# Town of Hilton Head Island Regular Design Review Board Meeting

Tuesday, March 11, 2014

**Town of Hilton Head Island**  
**Design Review Board**  
**Minutes of the Tuesday, February 25, 2014 Meeting**  
**1:15p.m – Benjamin M. Racusin Council Chambers**

PROJECT NAME: Reilleys Grill & Bar – Alteration/Addition

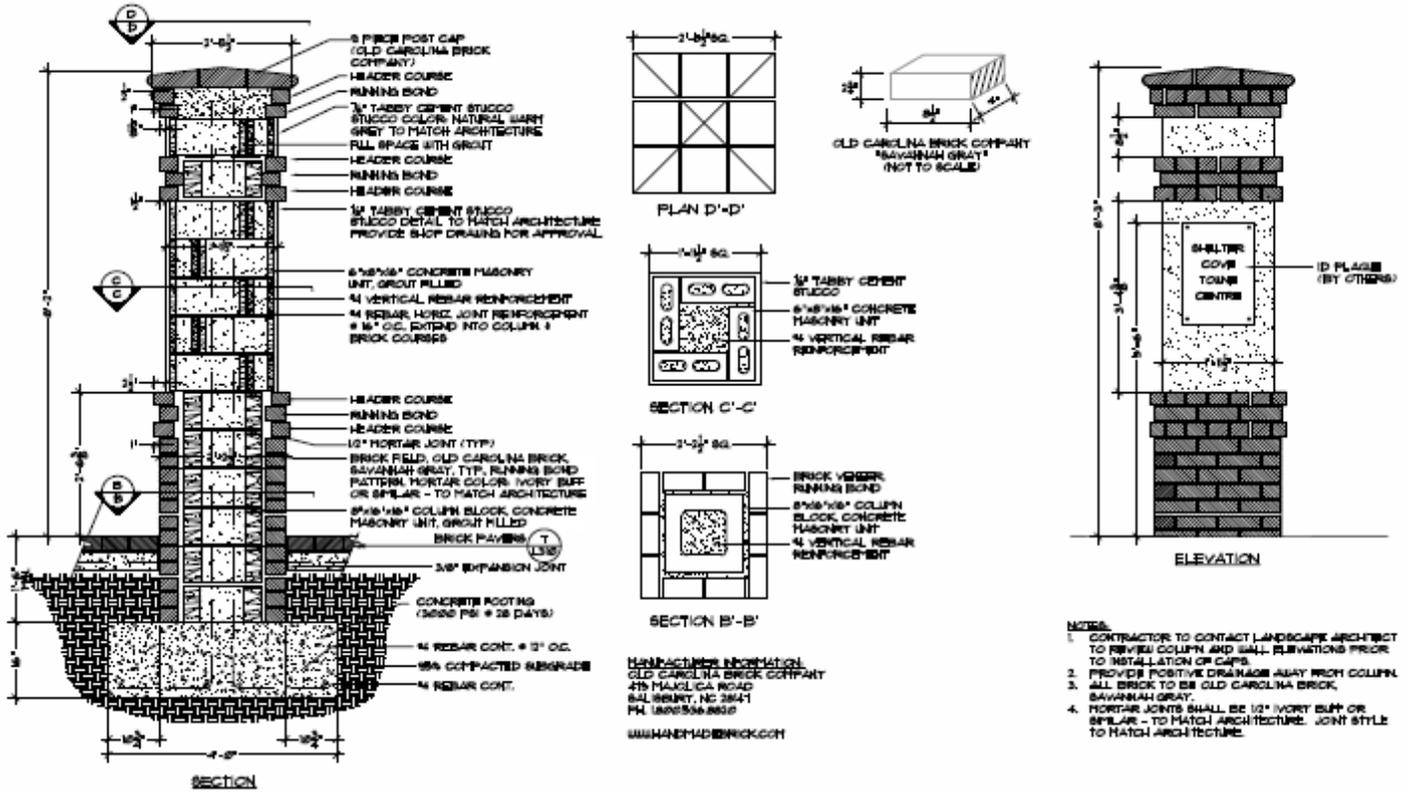
First, the developer requests that the columns identified as H3 on the landscape drawings be eliminated and that the smaller columns identified as H5 be changed to a tabby column with a brick cap. The developer also requests that the wall sections between the H5 columns (labeled as H4) be changed to a podocarpus hedge. Benches will be added to replace any seating provided by the H4 knee walls.

Secondly, the developer requests that the various striped awnings be replaced with solid colored awnings recommended by the project architect.

- Contributing factors to remove H-3 columns:
  - The H-3 columns block the architecture of the buildings
  - The H-3 columns did not provide lighting or seating opportunities for patrons

3 COLUMN AT KNEE WALL  
 SCALE 3/4" = 1'-0"

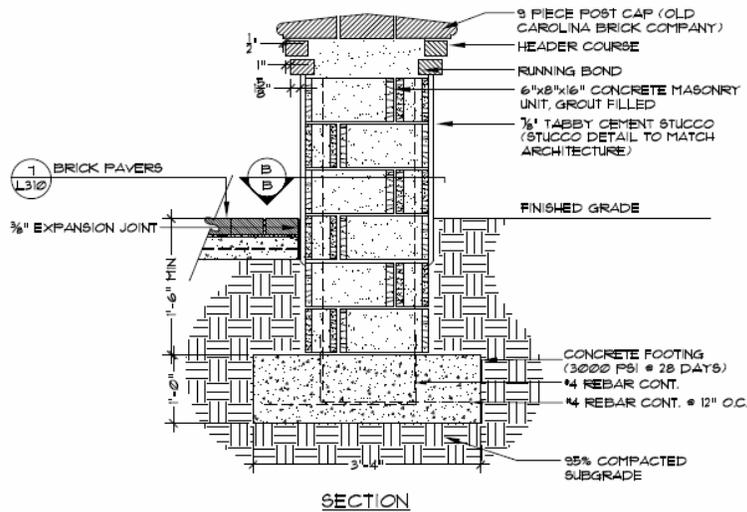
- Contributing factors to change the H-5 columns and replace certain H4 kneewalls with a podocarpus hedge:
  - Preliminary park plans indicate that tabby columns and walls will be used

- The project has a great deal of hardscape details in the plan, by replacing certain H4 kneewalls with a podocarpus hedge, the separation of hardscape and softscape can still be achieved and the project will benefit from more landscape elements.

H3 Columns to be removed:

H5 columns and knee wall

1. Propose something to take the place of the large columns as a punctuation point, i.e. continue the line of palm trees.
2. Tabby stucco with brick caps are appropriate for small columns.
3. Re-evaluate the landscape adjacent to the proposed hedge. In most locations the back of the knee wall was planted with a low shrub.
4. Reconsider addition of brighter colors, including “Tuscan”, “Sky Blue”, and “Aquamarine”. Provide color sample board for comparison of paint palette to fabric palette.

3 COLUMN AT KNEE WALL  
 L313 SCALE 3/4" = 1'-0"

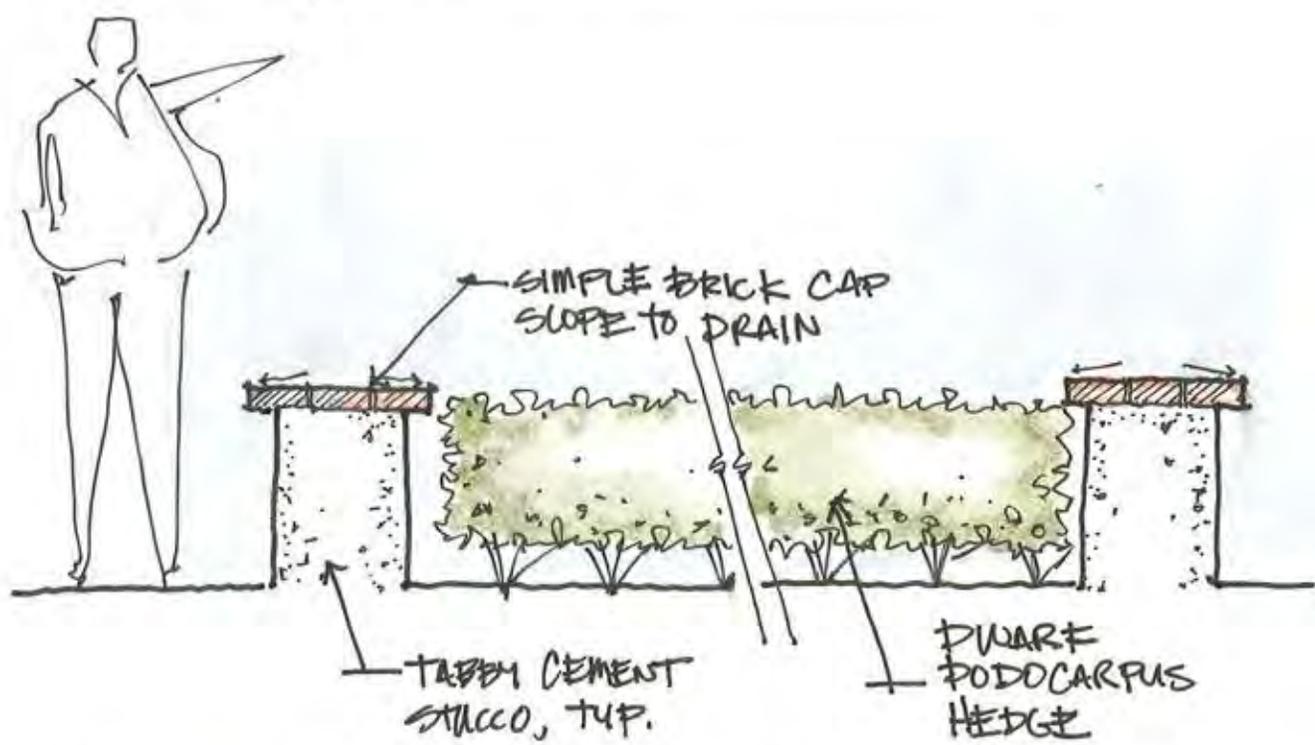
PROPOSED COLUMN / HEDGE

1. Eliminating large columns located at intersections of “Main Street” at Shelter Cove Lane, William Hilton Parkway, and the driveway connecting Kroger & Belk.
2. Changing the small columns to tabby stucco with brick caps.
3. Eliminating the cheek wall between the small columns and replacing it with a podocarpus hedge. Benches would be added where appropriate to provide seating lost due to eliminating the cheek wall.
4. Replacing striped awnings with solid colored awnings, to be selected on a case-by-case basis from a palette of 9 colors.
